Inspection Report, February 15 2024 Cresson Project M-1980-244

MINERALS PROGRAM INSPECTION REPORT
PHONE: (303) 866-3567

MINE NAME: Cresson Project	MINE/PROSPECTING ID#: M-1980-244	MINERAL: Gold and silver	COUNTY: Teller
INSPECTION TYPE: Monitoring	WEATHER: Clear	INSP. DATE: February 15, 2024	INSP. TIME: 10:00
OPERATOR: Cripple Creek & Victor Gold Mining Company	OPERATOR REPRESENTATIVE: Katie Blake	TYPE OF OPERATION: 112d-3 - Designated Mining Operation	
REASON FOR INSPECTION: Priority – reported ore stacking issue In VLF 2 Phase III.	BOND CALCULATION TYPE: None	BOND AMOUNT: \$291,100,000.00	
DATE OF COMPLAINT: NA	POST INSP. CONTACTS: None	JOINT INSP. AGENCY: None	
INSPECTOR(S): Nikie Gagnon	INSPECTOR'S SIGNATURE: 	SIGNATURE DATE: March 6, 2024

Cripple Creek and Victor Mine VLF 2 Phase 3A Work Plan

Photo 3: Closeup of the ROM material pushed down into Cell 5.

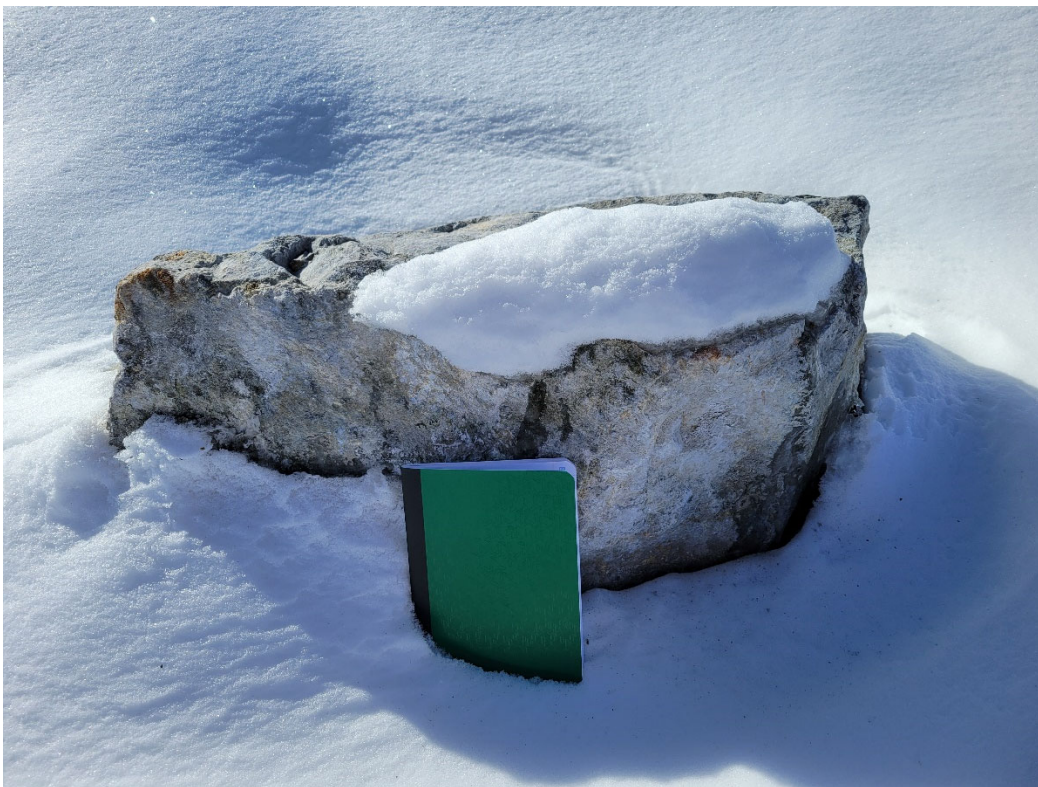
The Division observed the base and slope of a 50-foot lift in Cell 5 where the ROM ore was placed in a downhill direction (See Photos 1-4). Kathy Steele explained that ROM material was pushed with a dozer from the top and the ore flowed downhill into Cell 5. The Phase 3A area was covered in several inches of snow and therefore the Division was unable to inspect the base of the slope to determine if there was any movement of the DCF underlying the stacked ROM material. Cells 5 & 6 are adjacent and to the south of the PSSA in the Phase 3A area and the cells are underlain by 80 MIL geomembrane. The ROM material observed was primarily <3 feet in diameter. The largest rock observed by the Division at the bottom of the slope is shown in Photo 4.

The Division observed Cells 5 and 6 from the top where the downhill ore stacking occurred on the 10,050 lift. (See Photos 5-8). The Operator stated that they were not stacking in the Phase 3A area on the day of this inspection and have not stacked additional material in Cells 5 or 6 since February 6. No evidence of further stacking or moving ore in Cell 6 was noted during this inspection. The area was blanketed in snow and no tracks were observed. The Division noted the entrance to Cells 5 & 6 have been blocked by a berm to ensure no additional stacking occurs in this area.

Old Controls: Stacking Order Guidance 10050 Lift

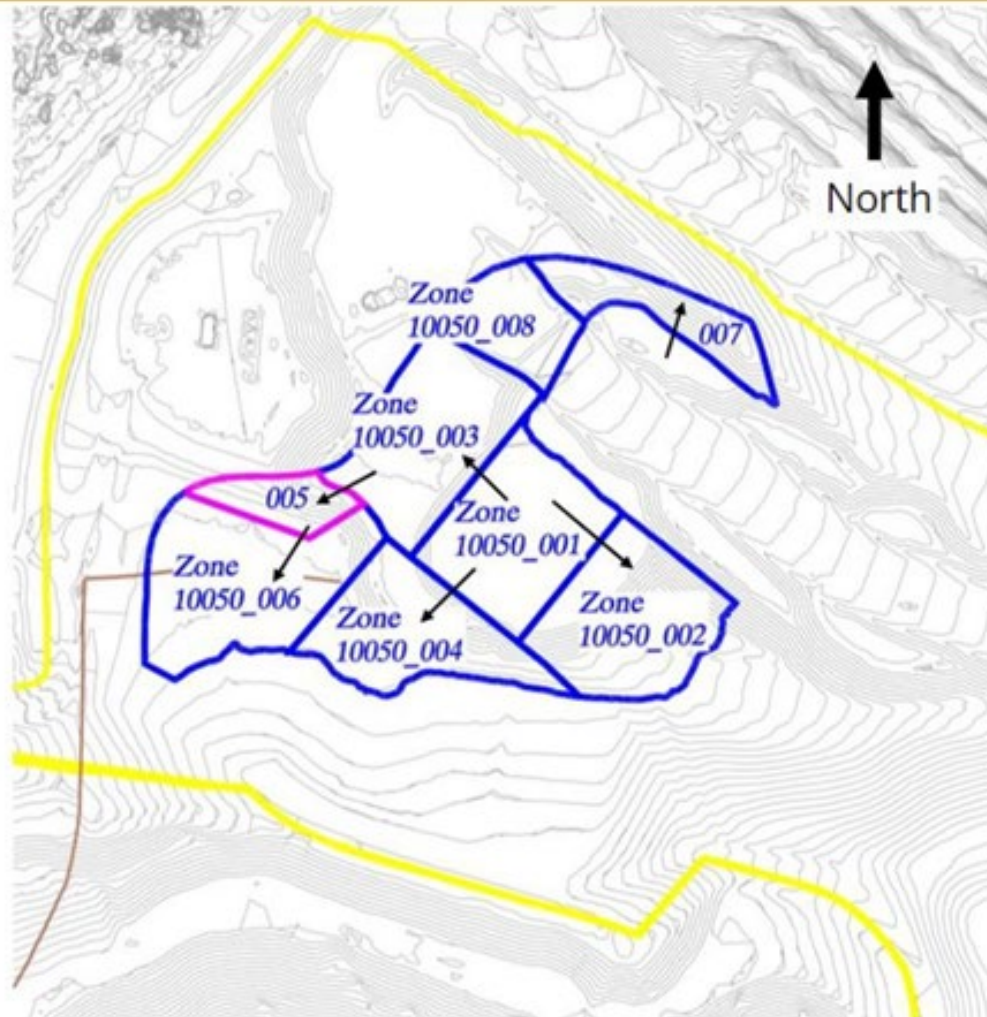
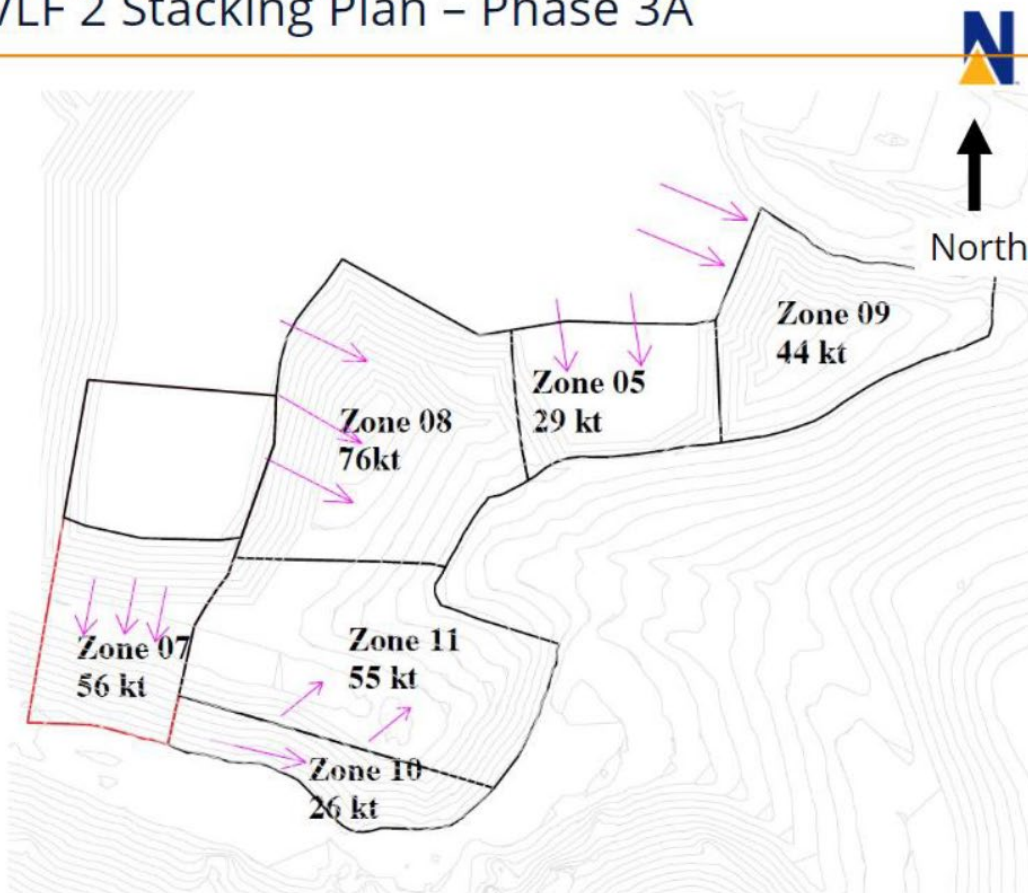
During a conference call on February 26, 2024, the Operator presented a VLF2 Phase 3A Work Plan to the Division which included a project schedule for exposing and repairing or replacing the liner in Cell 5, a figure displaying new controls for stacking order guidance, and a map showing a 2-acre exclusion zone above/adjacent to the VLF2 PSSA where no leaching would be allowed until the liner is recertified. During the call, the Division and Operator discussed a few minor changes to the plan and on February 27, 2024, the Division accepted the revised VLF2 Phase 3A Work Plan/Corrective Action to address the ore stacking violation (see Attachment 2.)

- Stacking order must be strictly followed.
- Overflows goes to VLF 2 10300
- Contact STP if you face any stacking challenges

More details added:

- Instructions
- Directions
- Communication with operators
